FROM: Peter Johansson
 TO: T10 SBP-2 *ad hoc* Working Group
 DATE: February 9, 1997
 RE: Unsolicited Status Handshake in SBP-2

The proposal below represents the working group's opinion, from the January 20 meeting in San Jose, that permission to store unsolicited status should be initially disabled at the time of a login or create stream request. Initiators that wish to accept unsolicited status may subsequently write to the UNSOLICITED_STATUS_ENABLE register each time a single instance of unsolicited status may be stored. The proposed modifications to the SBP-2 Revision 2 clause are shown by change bars.

Figure 1 – UNSOLICITED_STATUS_ENABLE~~STATUS_ACKNOWLEDGE~~ format

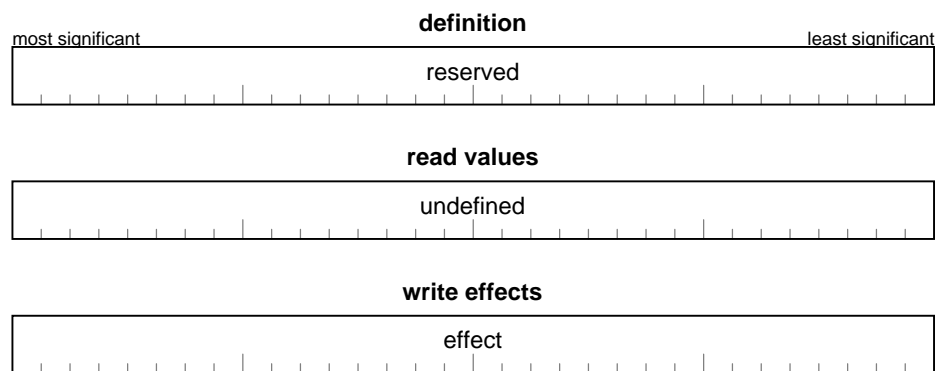
6.4.5 UNSOLICITED_STATUS_ENABLE~~STATUS_ACKNOWLEDGE~~ register

The UNSOLICITED_STATUS_ENABLE~~STATUS_ACKNOWLEDGE~~ register provides a location at which the initiator may grant the target permission to store an unsolicited status block~~signal the target that unsolicited status has been received~~. The definition of this write-only register is given by Figure 1 below.

A quadlet write of any value to this register shall cause the fetch agent's unsolicited status enabled~~status acknowledgment~~ variable to be set to one. A successful login or create stream request~~isochronous login~~ shall zero~~set~~ the corresponding unsolicited status enabled~~status acknowledgment~~ variable ~~to one~~. As described in 9.4, any time a target stores an unsolicited status block it shall zero the unsolicited status enabled variable for that login. Before the target may store a subsequent unsolicited status block it is necessary for the initiator to write to the UNSOLICITED_STATUS_ENABLE register.
